PROPOSED TECHNICAL SPECIFICATIONS REVISIONS

BROWNS FERRY NUCLEAR PLANT

UNITS 1, 2, AND 3

(TVA BFN TS 252)

Figure 1

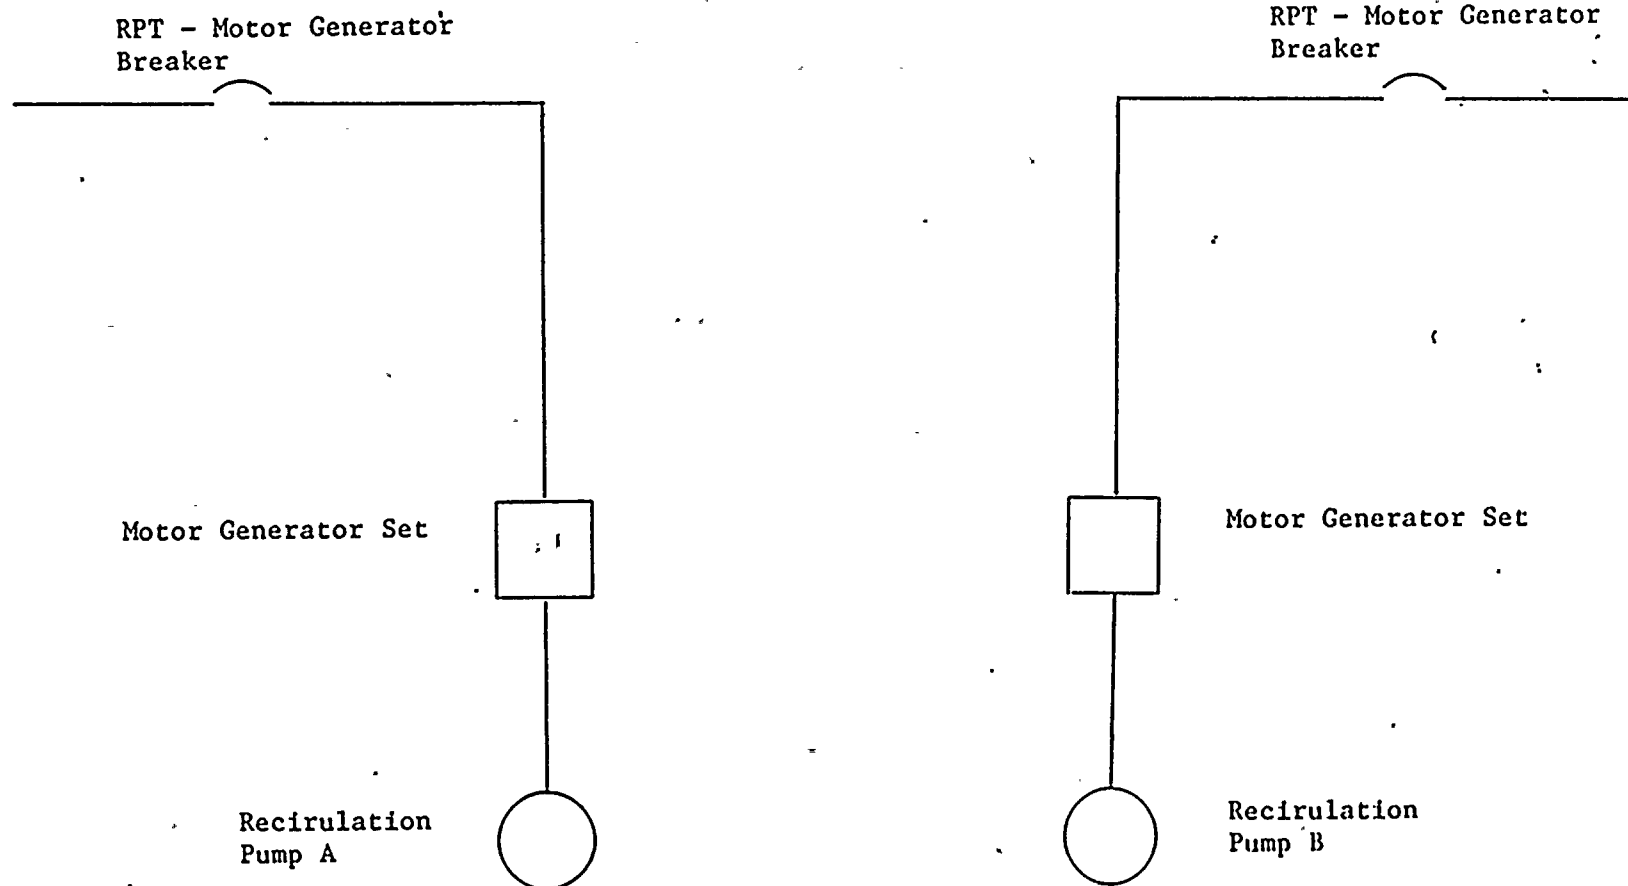
The ATWS-RPT System will replace the existing RPT-MG logic. The existing RPT-MG trip coils are located before the motor generator (MG) sets (figure 1). When a trip signal is received, the RPT-MG breaker is tripped. The MG set will supply power to the recirculation pump motor until the MG set inertia is spent.

The ATWS-RPT System will provide for a faster stopping of recirculation flow by eliminating any MG set inertia effects on the ATWS-RPT. The ATWS-RPT modification employs the "Monticello" design using the two end-of-cycle (EOC) trip breakers. These breakers are located between the MG output and the recirculation pump motor (figure 2). When a trip signal is received, the EOC breakers are tripped and the recirculation pumps coast down. Core power is reduced by flow coast down and by the subsequent voiding of the reactor core. The ATWS-RPT allows for quicker power reduction as it eliminates the MG set inertia.
